**REMARKS**

Serial No.: 09/420,616

Attorney Docket No.: 99P7918US

# Annotated Sheet showing changes

FIG. 4

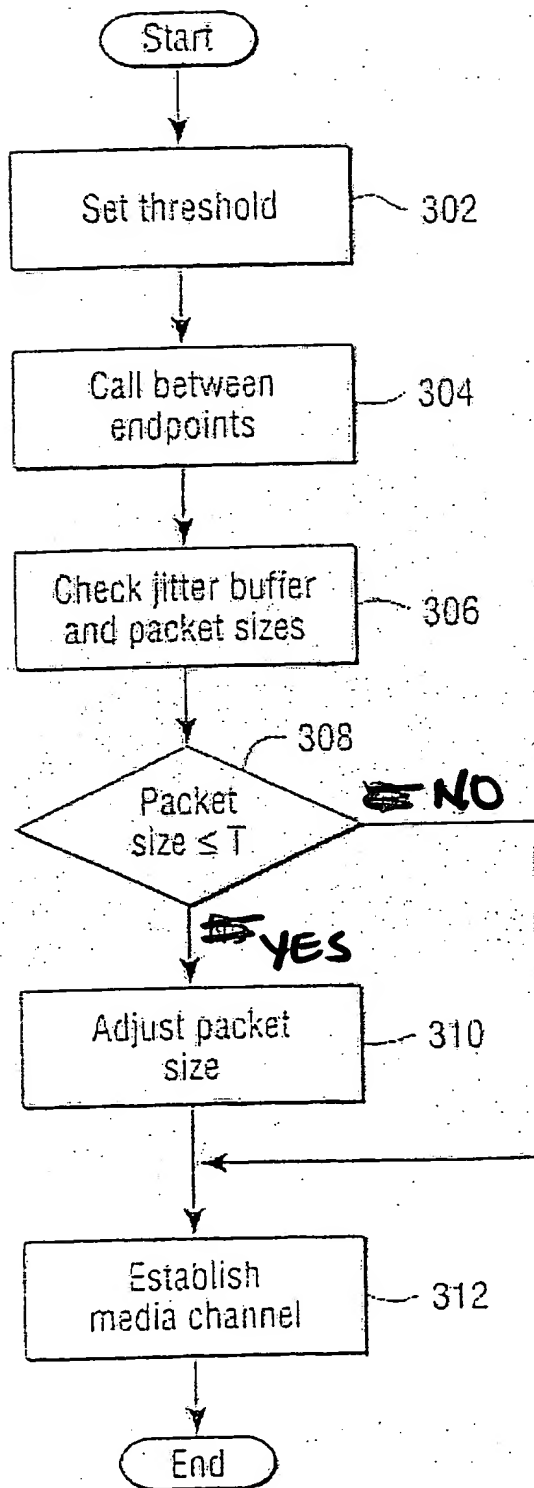
Upon entry of the instant Amendment, Claims 1-16 are pending. Claims 1, 5, 9, and 14 have been amended, and claim 16 has been added, to more particularly point out Applicants' invention. The figures were objected to because in FIG. 4, block 308 was indicated to have the N and Y branches mislabeled. The figures have been amended to correct the branch labeling. No new matter has been added.
